File No. LDA10-0125

RE: Tentative plan of subdivision to create 123 single detached residential lots, 202 semi-detached residential lots, two (2) medium density residential lot, and four (4) public utility lots from a portion of Lot A, Plan 806TR; **WINDERMERE**

**I The Subdivision by Plan is APPROVED on August 12, 2010 subject to the following conditions:**

## SUBDIVISION CONDITIONS OF APPROVAL MAP

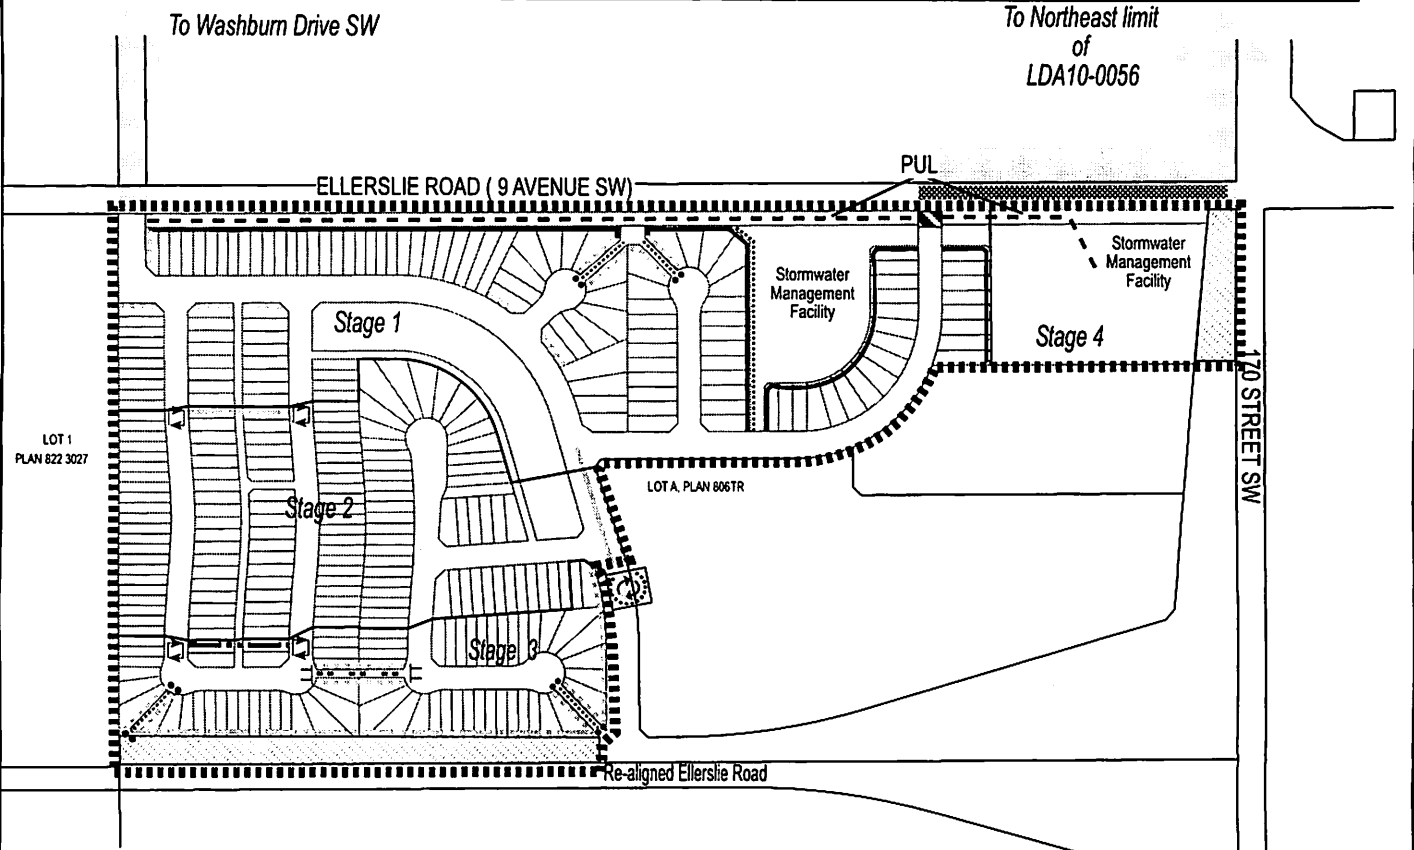
4. that the owner be permitted to register this plan of subdivision in stages, as shown on the "Conditions of Approval" map, Enclosure I, at the discretion of the Chief Subdivision Officer, having regard to the provision of roadways and logical extension of services;

5. that the owner dedicate road right-of-way to conform to an approved Concept Plan or to the satisfaction of the Transportation Department for the re-aligned Ellerslie Road west of the collector roadway to the westerly subdivision boundary and for 170 Street adjacent to the stormwater management facility, as shown on the "Conditions of Approval" map, Enclosure I;

7. that the road right-of-way width for the main collector be increased to 24 m to the satisfaction of the Transportation Department, in the location as shown on the "Conditions of Approval" map, Enclosure I;

9. that the owner dedicate and register the walkways as road right-of-way as shown on the “Conditions of Approval” map, Enclosure I; and
10. that the owner pay all outstanding property taxes prior to the endorsement of the plan of subdivision.

10. that grading plans for the north/south collector be included in the submission of engineering drawings for stage 1;
11. that the owner reconstruct the existing Ellerslie Road (government road allowance) west of 170 Street to the first roadway intersection to a two lane rural roadway standard, as shown on the “Conditions of Approval” map, Enclosure I;

12. that the owner provides a zebra marked crosswalk with curb ramps and pedestrian signage at the mid-block crossing, to the satisfaction of the Transportation Department, as shown on the “Conditions of Approval” map, Enclosure I;

13. that the owner construct a 3 m asphalt multi-use trail with a dividing yellow centreline and “Shared Use” signage, as shown on the “Conditions of Approval” map, Enclosure I;

14. that the owner construct walkways containing 1.5 m concrete sidewalks with bollards and lighting, as shown on the “Conditions of Approval” map, Enclosure I;

15. that the owner construct the emergency access walkway with a 3 m concrete sidewalk with T bollards and lighting, as shown on the "Conditions of Approval" map, Enclosure I;

16. that the owner construct 12 m radius gravel temporary turnarounds with bollards or mini-barriers to the satisfaction of the Transportation Department, or 6 m wide gravel temporary roadway connections, as shown on the "Conditions of Approval" map, Enclosure I;

17. that the owner construct an offset 17 m radius asphalt temporary transit turnaround with bollards or mini-barriers to the satisfaction of the Transportation Department as shown on the "Conditions of Approval" map, Enclosure I. The turnaround will be required to be gravel prior to CCC and asphalt prior to FAC, or at the discretion and direction of the Transportation Department;

18. that the owner construct all fences positioned wholly on privately-owned lands to the satisfaction of the Asset Management and Public Works Department in the locations as shown on the "Conditions of Approval" map, Enclosure I; and
